WILLOW ROCK ENERGY STORAGE
CENTER

Docket No. 21-AFC-02

COMMENTS OF CALIFORNIA UNIONS FOR RELIABLE ENERGY
ON THE PRELIMINARY STAFF ASSESSMENT

June 16, 2025

Figure 2 Noise measurements at CML-1 (left) and CML-6 (right) (data plotted from SAFC, ESHDh)

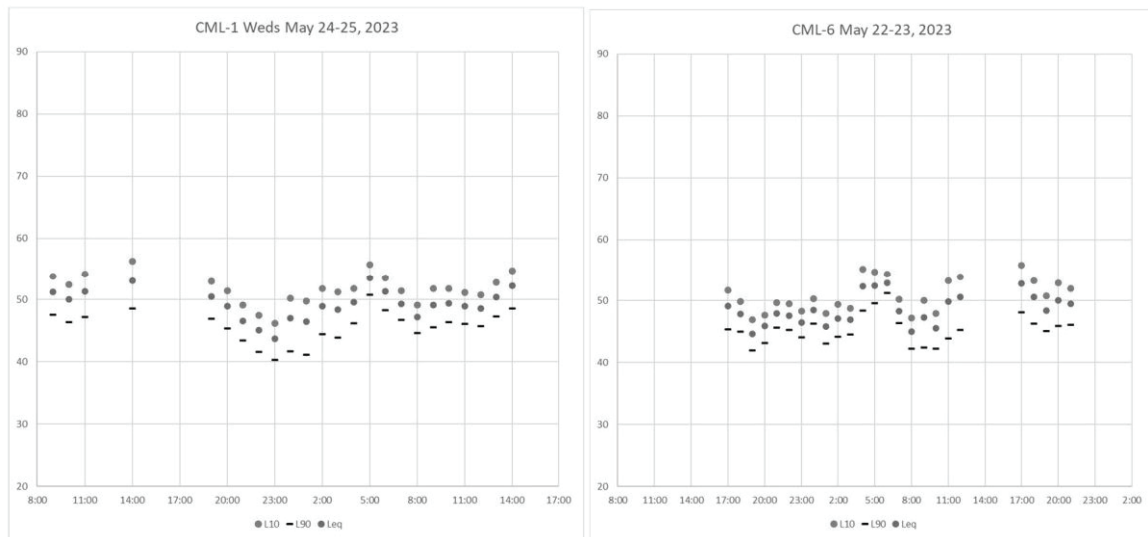
2. The PSA underreports the significance of the WRESC project. The existing noise environment can be characterized in several ways, yet the PSA only focuses on the equivalent level, L_{eq} , and the 24-hour day-night level, L_{dn} . Since this is a rural community, the **background noise** is an essential issue to consider as this is the noise level that people hear when they're trying to sleep.

- The SAFC provides data characterizing the **background noise** in the project area with measurements of the L_{90} , or noise level exceeded 90% of the time. This is in alignment with common usage in environmental noise analysis. Outdoor noise sources which are continuous in nature will strongly affect the L_{90} ; continuous sources include turbines, compressors, generators, heat exchangers, pumps, transformers etc. These types of noise sources are associated with the WRESC; thus, the continuous noise generated by the WRESC would directly increase the background noise in the community. For graphical comparison, see Figure 2 which plots some of the long-term noise results measured at CML-1 (near the highway), and CML-6 (Project site, about 2,000 ft from the highway). The background noise is shown as the black dashes.

- The PSA uses the wrong metric. The ambient noise is the combination of all noises in the environment, including continuous noise and intermittent noise, and it is often measured with the equivalent level, or L_{eq} . The L_{eq} can be strongly influenced by high level, short duration noises such as passing cars, aircraft overflights, etc. The L_{eq} is not a metric applicable to the background noise level. The PSA omits any reference to the background noise and only compares the WRESC to the ambient noise (PSA Section 5.9, page 5.9-8). Table 1 below compares the combined operational noise levels with the baseline levels compared to the baseline conditions. These results were taken from the SAFC analysis (ESHDh, Table 5.7-13 p. 5.7-28), however the SAFC and the PSA erroneously compare apples to oranges; the SAFC analysis does not compare the project noise to the background level (L_{90}); they calculate a “day-night” predicted noise level (L_{dn}) which is compared to the existing L_{dn} ; there is no calculation of the noise increase relative to the background (L_{90}), and their calculation obscures the nighttime noise impact.

Figure 1. Example of proposed transmission pole construction sites (blue arrows) with no existing or proposed road access. Image adapted from Figure DR125-5 provided in response to CEC Data Requests Set 6.

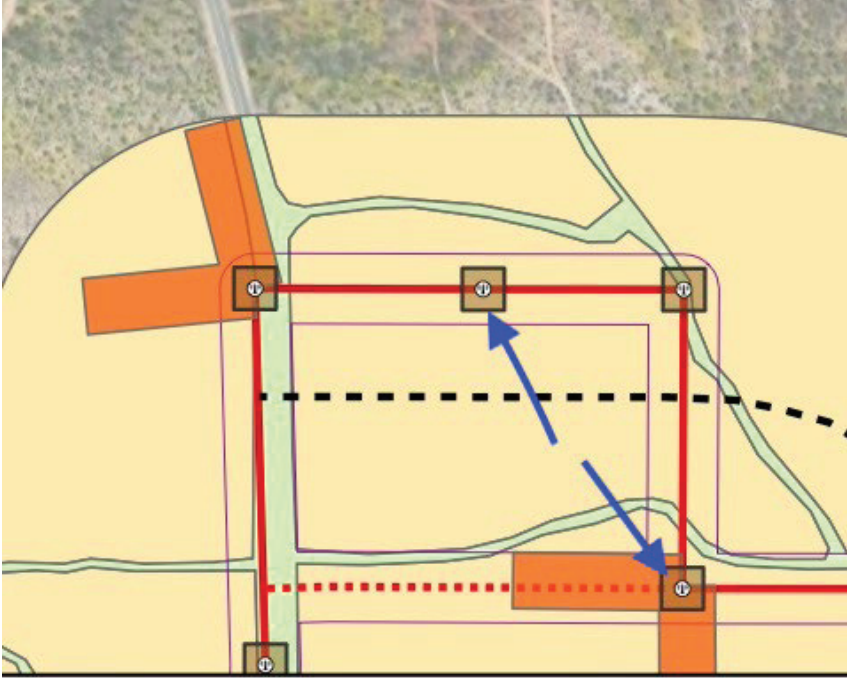
Second, the figures provided by the Applicant depict several proposed transmission poles (and associated pole construction sites) that are not adjacent to an existing road, and for which no access roads have been proposed (e.g., Figure 1, below).⁶ Road construction or other forms of ground disturbance would be required to access these pole locations and construction sites.

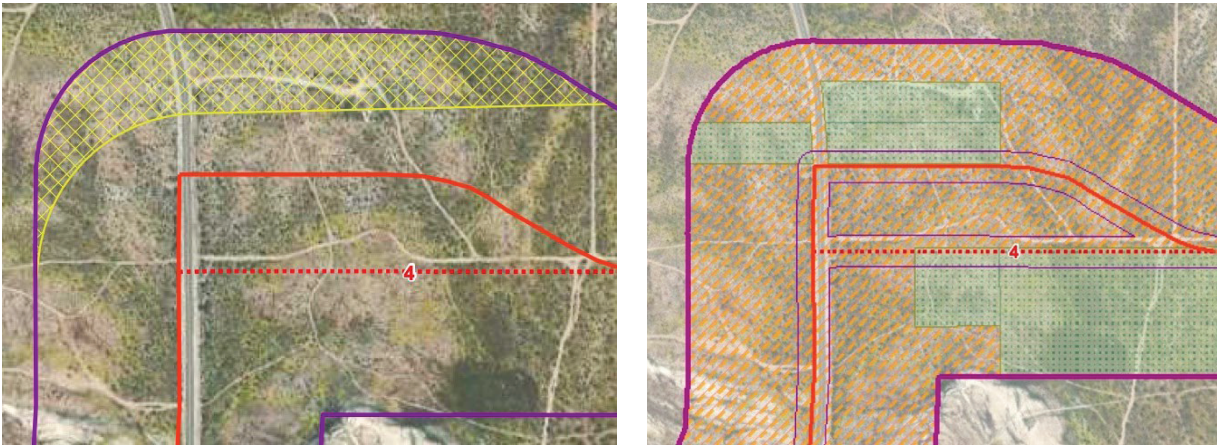
have right of entry. There are numerous inconsistencies between these two map books.²⁵ For example, the map book in TN 256491 identifies a “not surveyed” area north of the preferred gen-tie route just east of Mojave-Tropico Road, but almost no “not surveyed” areas in the gen-tie study area along Mojave-Tropico Road. This is inconsistent with the map book provided in TN 259338, which shows numerous “no right of entry” areas within this portion of the gen-tie study area, including areas within the 50-foot gen-tie corridor and substantial portions of the gen-tie study area along Mojave-Tropico Road (Figure 2, below).

Figure 6. Example of “roads” (overlain with arrows) driven to conduct Swainson’s hawk surveys. Rosamond Blvd is at bottom of image. Structure in bottom left corner is approximately 700 feet east of 75th Street W.

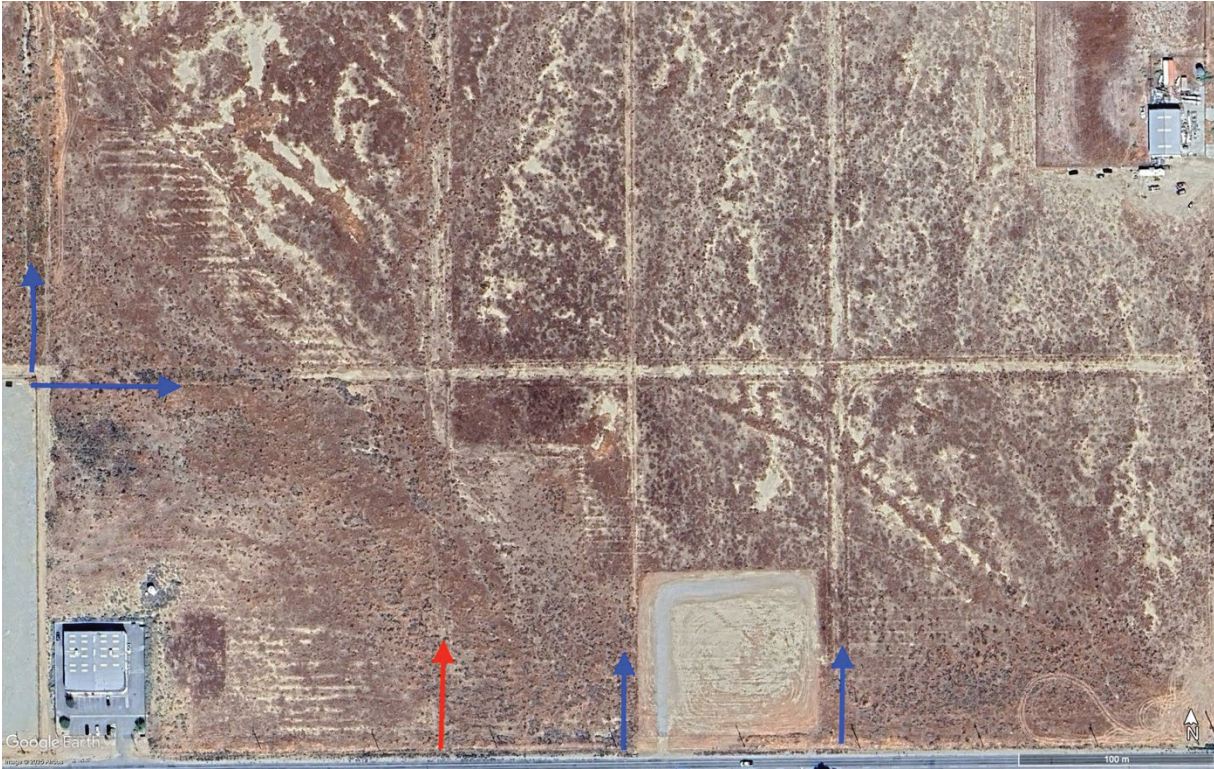
Figure 7. Google Street View from Rosamond Blvd facing north. Red arrow in the image corresponds with red arrow in Figure 6. Contrary to what is depicted in the Applicant's map (of the Swainson's hawk survey routes), there is no road intersecting Rosamond Blvd at this location.
